1976/65. Investigations of a landslip at Alexander Terrace, Stanley.

W.L. Matthews

Figure 1.

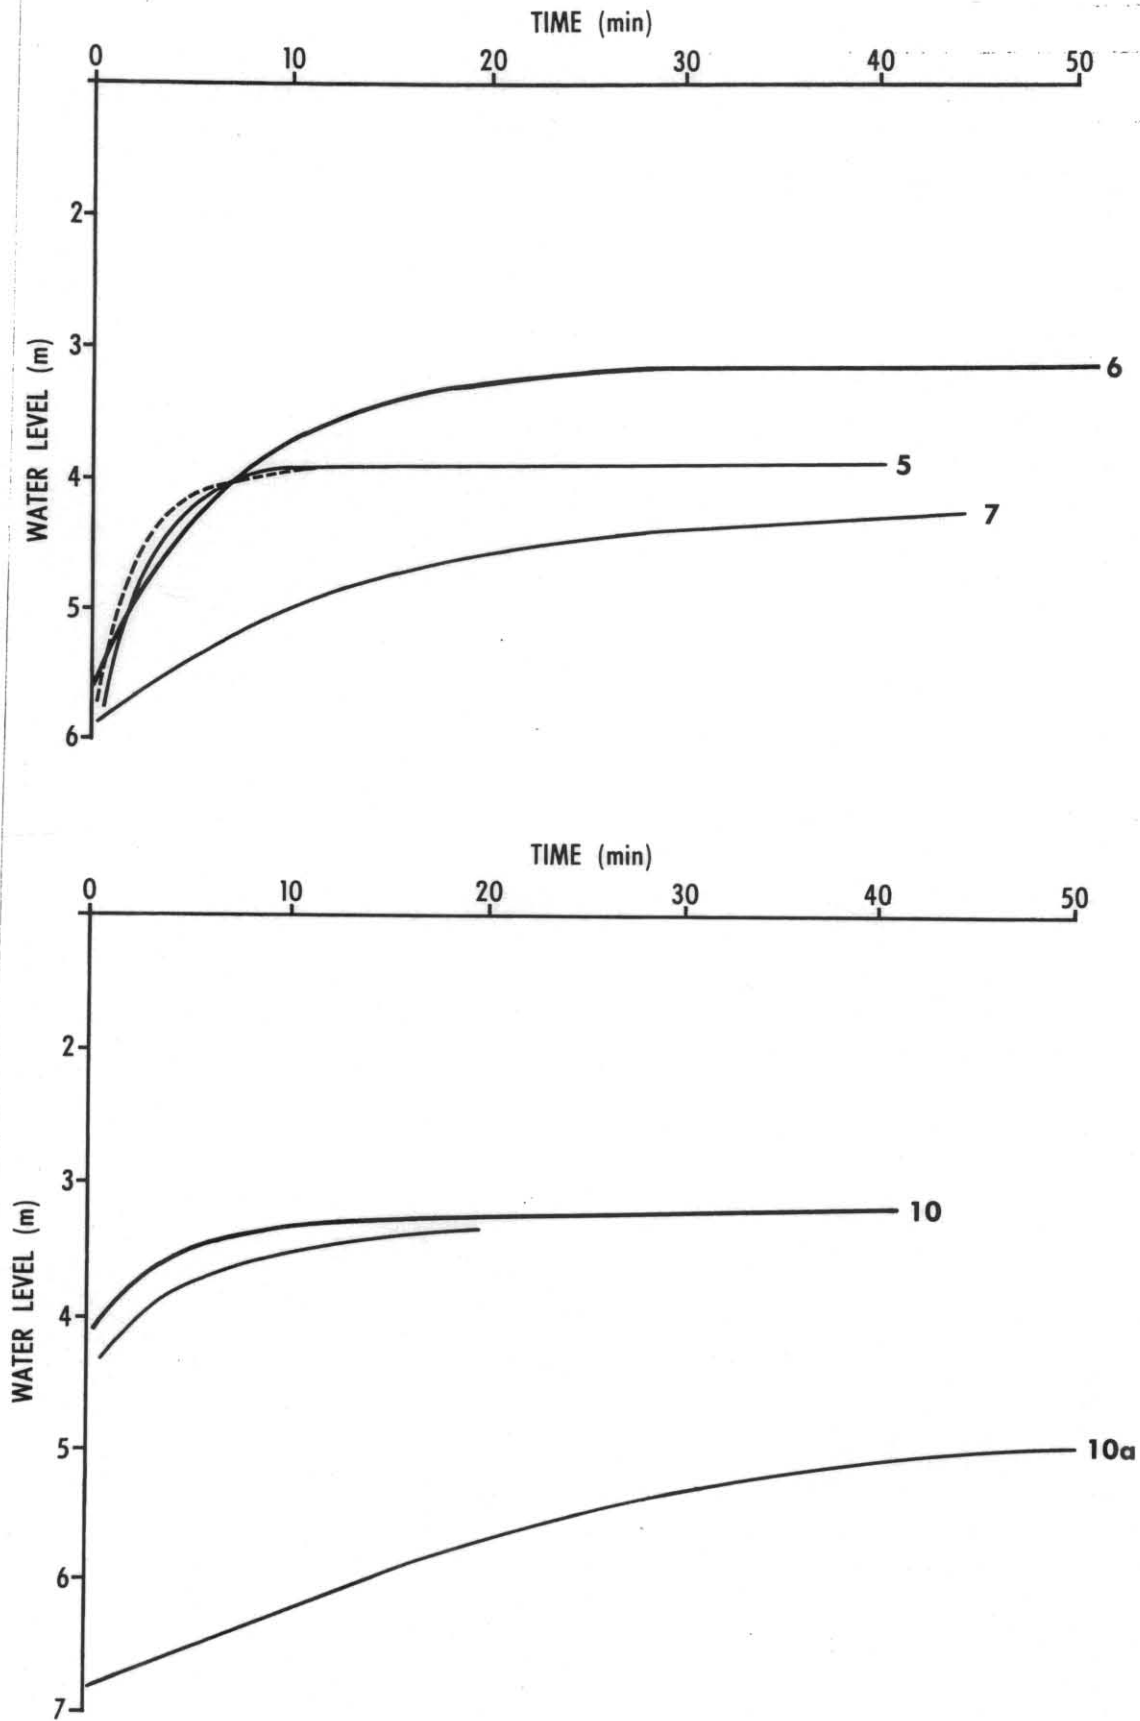
There was some doubt, from the information in the reports (Golder and Associates, 1975a, b) that the proposed system would drain the area as a test pit dug on the line of the proposed drain failed to encounter any water to a level deeper than that of the drain. It was therefore thought possible that the water affecting the slip may be pressure water contained in an aquifer below the level of the drain.

The recent investigations have shown that some water is contained in the tuff and some is contained in the overlying talus. The tuff is very permeable in the vicinity of Hole 9 but is much less so where encountered in the test pit and in Hole 10. It has not been determined whether there is pressure water contained in the tuff but the drain as proposed will drain water from the talus and lower the water table.

As the tuff in the test pit and in Hole 10 has a low permeability (as opposed to the high permeability of the tuff around Hole 9) the gravel filled holes in the base of the drain suggested by Golder and Associates would probably not add significantly to the drainage in the tuff and are probably unnecessary.

Seepage from the drain may cause the water table to rise between Holes 1 and 9 as it is not proposed to extend the drain to the depth of this low point in the water table. This could produce slightly less stable conditions in this area.
